30 October 2018

16734

RE: PICTON HIGH SCHOOL REDEVELOPMENT (SSD 17_8640) RESPONSE TO SUBMISSIONS

Figure 1 Recommended changes to the bus bay as a result of the Swept Path Assessment

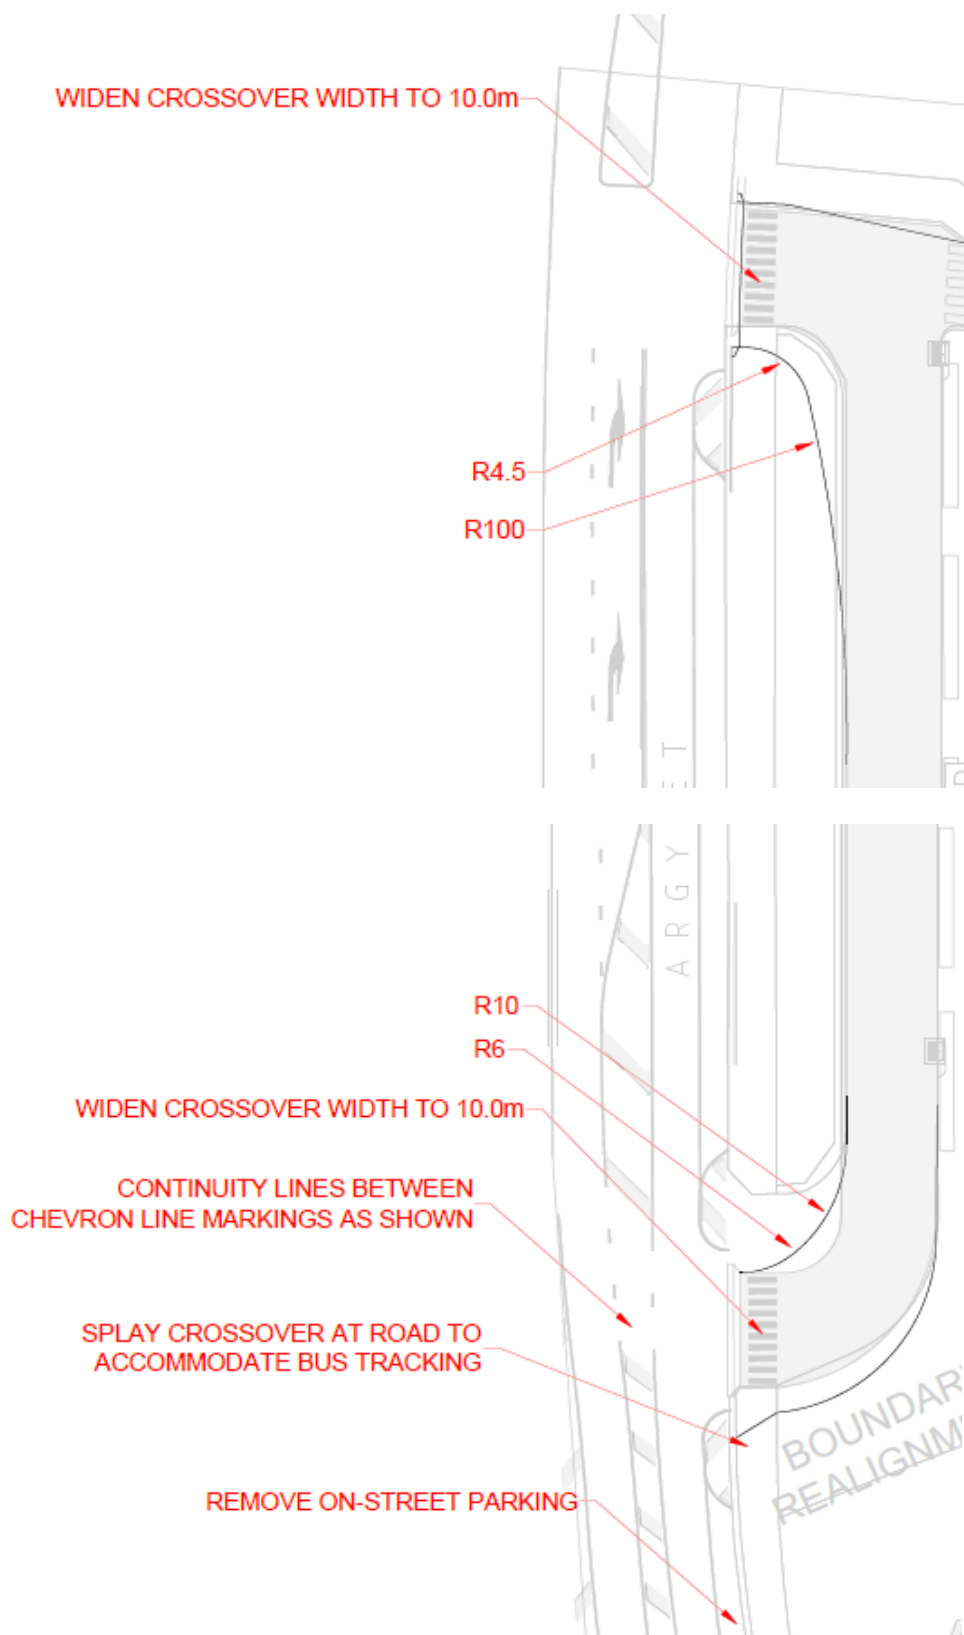
- An assessment of buses exiting the site whilst a bus is parked in the southernmost bus parking bay. In order for a bus to be able to exit the site in this arrangement it is recommended that the kerb line be amended as shown within the relevant figures.

- An assessment of buses accessing the site whilst a bus is parked in the northernmost bus parking bay. The assessment shows that a bus accessing the site from the north can access the site in this arrangement with some modification to the kerb line. However, a bus accessing the site from the south would be required to wait for the bus to exit the bus bay. In this event, the bus would be able to wait on-site or within the right turn bay. To maintain a narrow crossover width at the northern site access to ensure pedestrian safety, and given the infrequent nature of this event occurring, and the low impact of buses waiting for a short period of time before accessing the bus bay, this arrangement is considered to be acceptable.

Accordingly, it is the kerb line has been amended as per the swept path diagrams, as shown in **Figure 1** below.

As detailed in **Section 1.2** and **Figure 1**, proposed amendments have been made to the bus bay in order to provide adequate room for buses to manoeuvre in accordance with the Swept Path Assessment undertaken by TDG (**Attachment D**). Modifications include:

- widening crossover width to 10m;
- removing on-street parking to the immediate south of the bus bay;
- splay crossover at road to accommodate bus tracking; and
- providing continuity lines between chevron markings as shown in **Figure 1**.
